Technical Service Bulletin

**Solitude 360RL Slide Room Flex-Guard Strap -
DS Dinette Slide**

16-005

Solitude 360RL

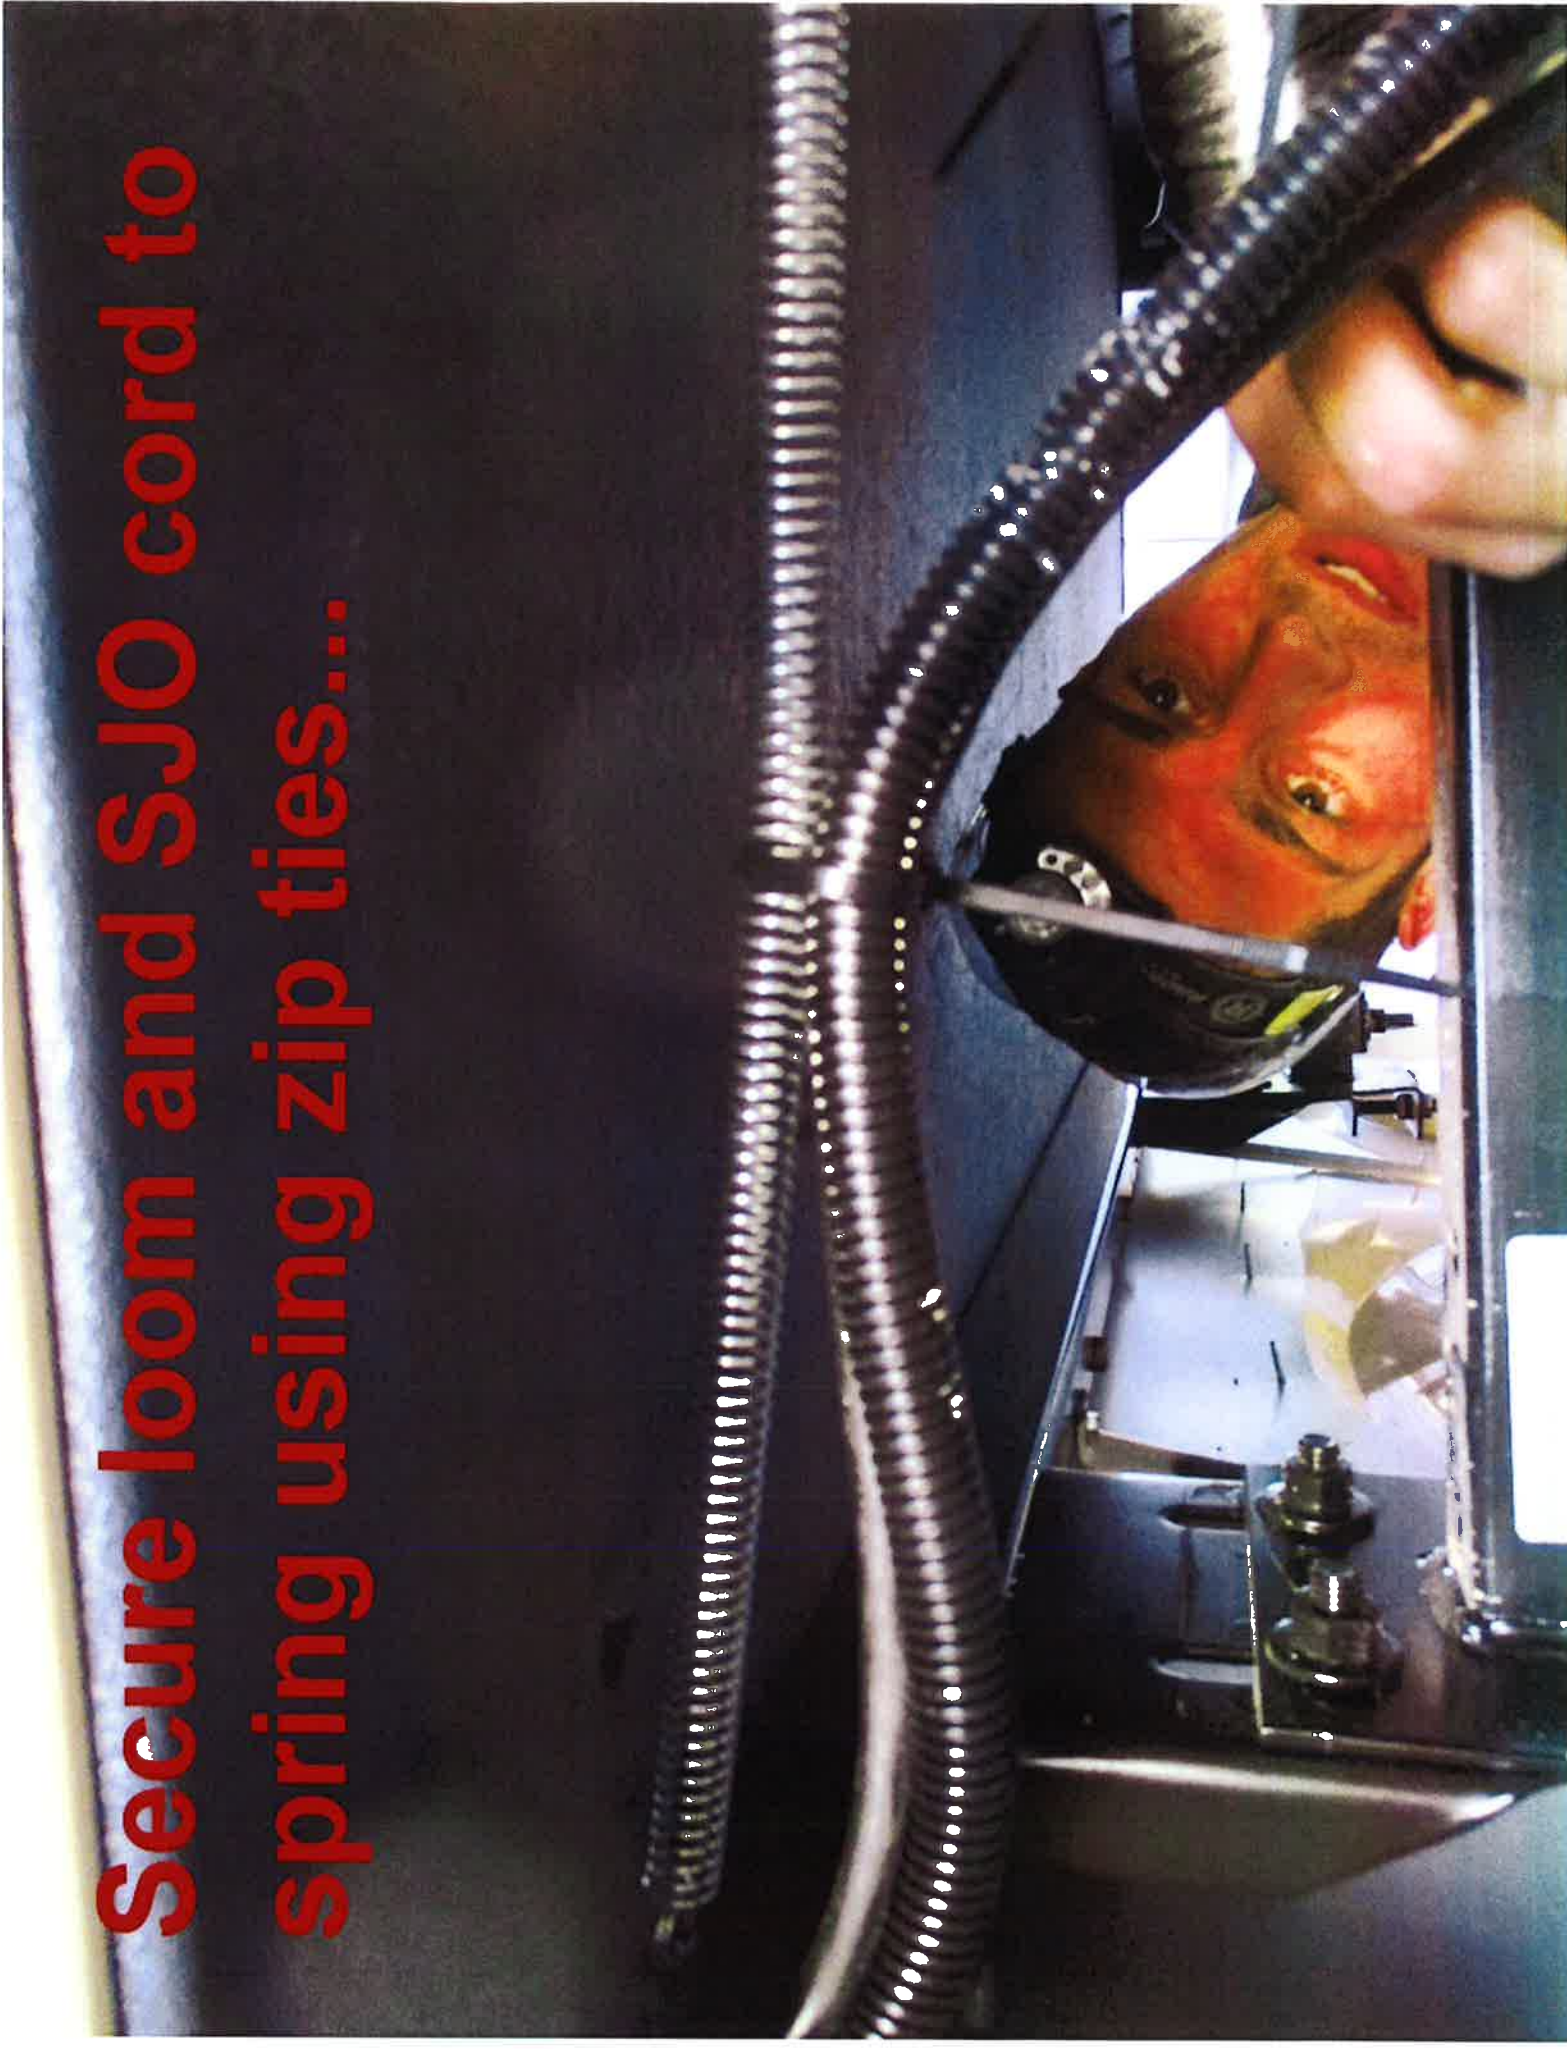
**Attach other end
of spring to darco
wrapped tube
using hole left
open in previous
step...**

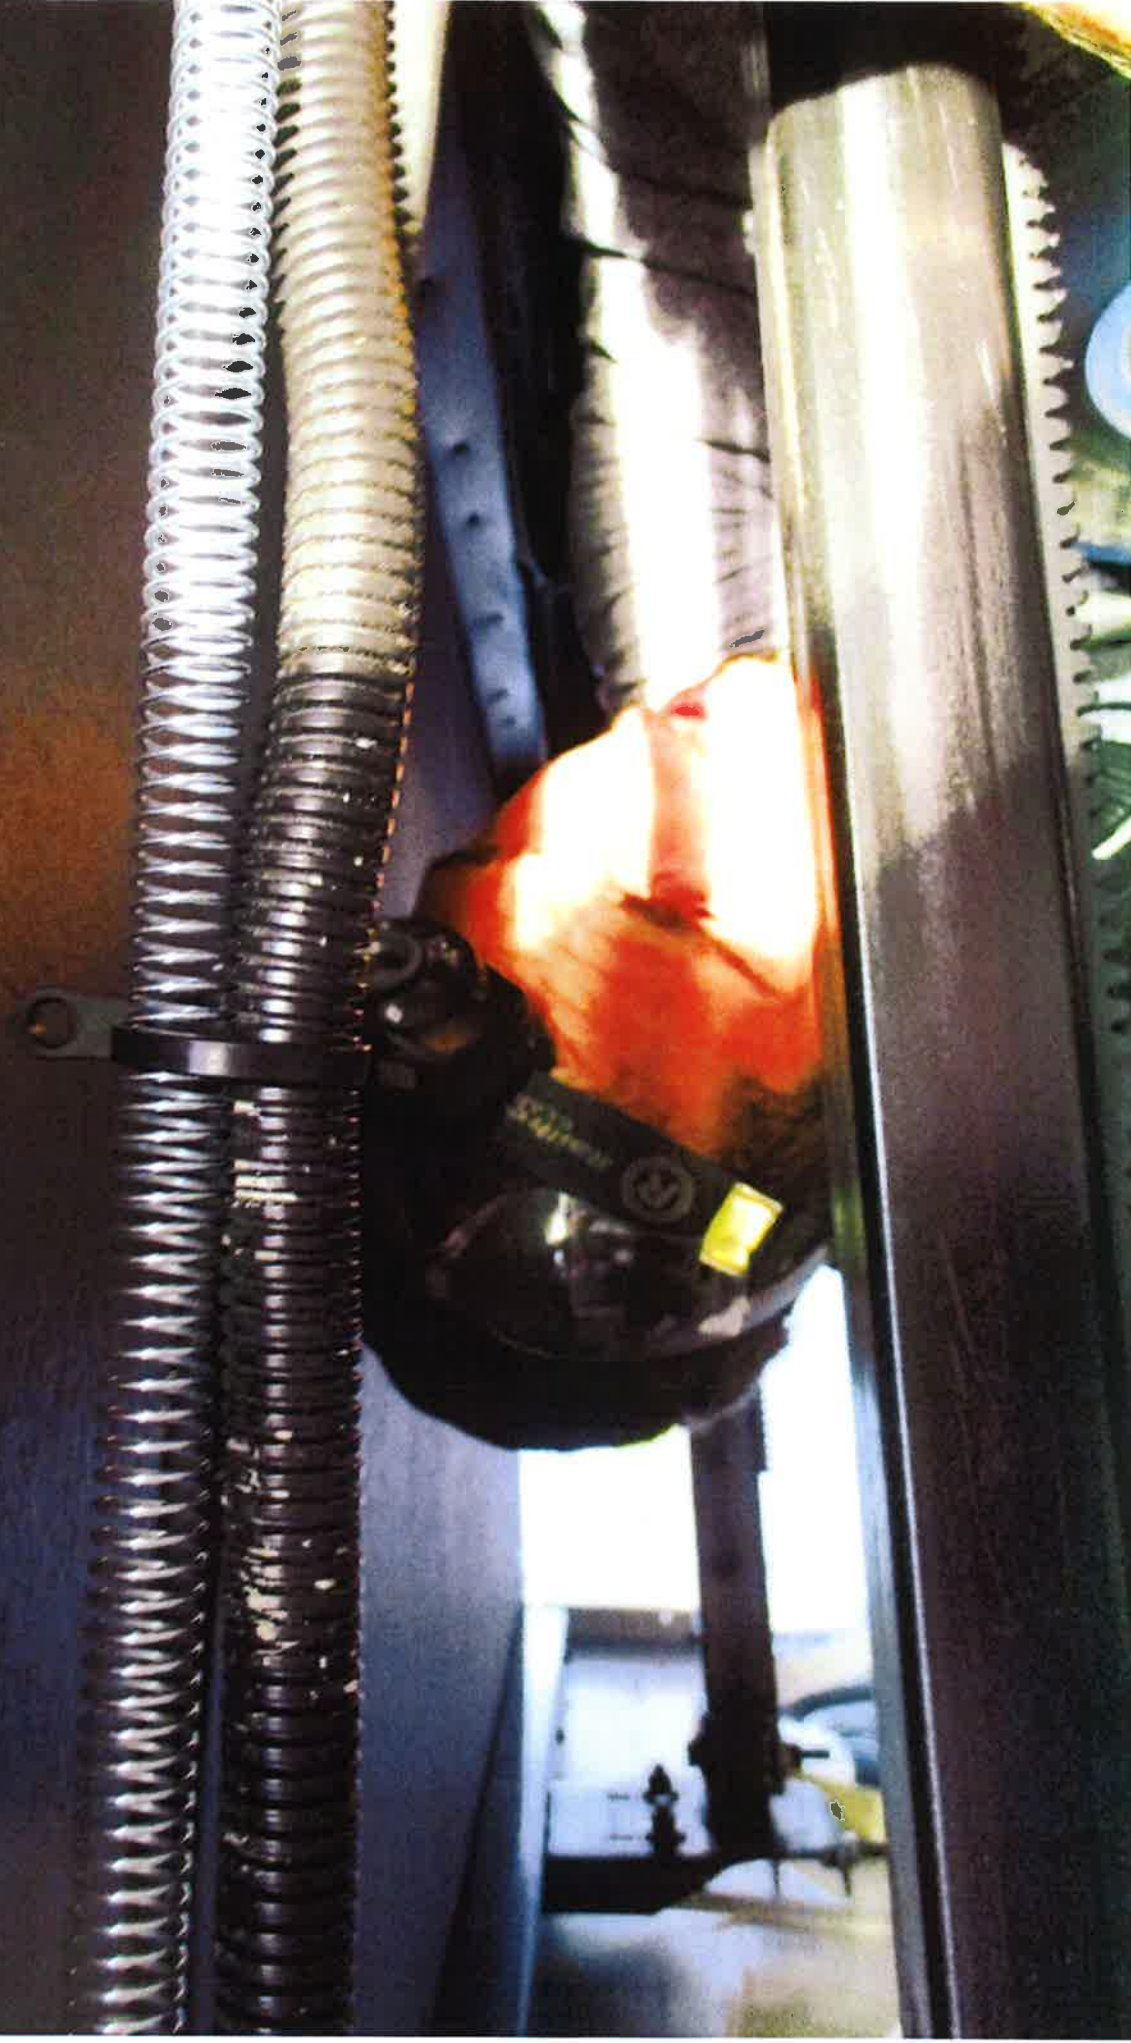
**Secure loom and SJO cord to
spring using zip ties...**

Zip tie towards middle of
spring...
